Advisory Plan Commission

Town of Brownsburg

Request Type: Development Plan Review

CASE NUMBER	PSDP-25-10
APPLICANT	Cody Nicholson & Caleah Brown, Permit Solutions, for McDonald's
LOCATION	SE Corner S. Green St. and Northfield Dr., Parcel 32-07-26-154-001.000-016
PARCEL SIZE	1.56 acres

Site and Zoning Map:

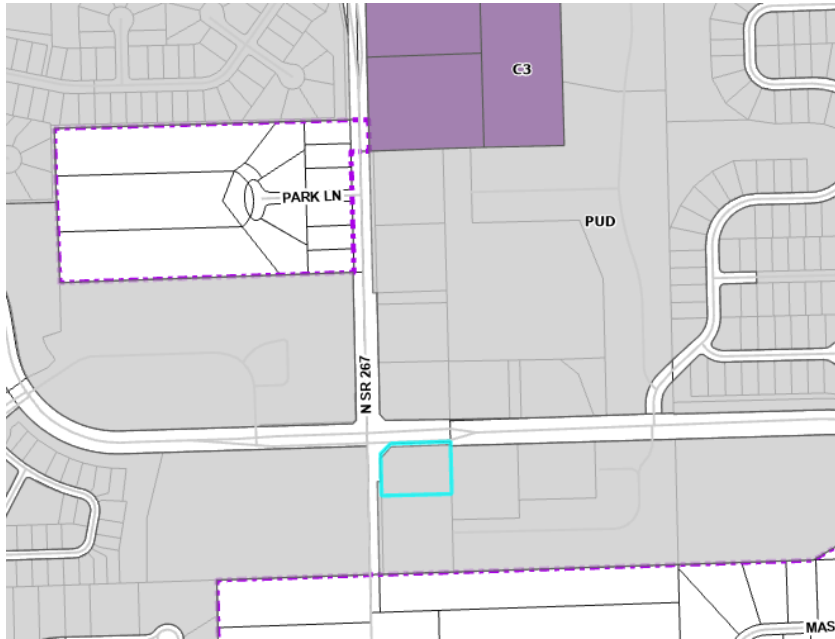
This project is a new McDonald's, with drive-thru, to be located at the southeast corner of S. Green Street and Northfield Drive. The restaurant will be accessed from Northfield Drive to the north and from a shared access with Christian Bros. to the south, from S. Green Street. The access point from S. Green Street will be moved to the north, straddling the property line between Christian Bros. and the proposed McDonald's.
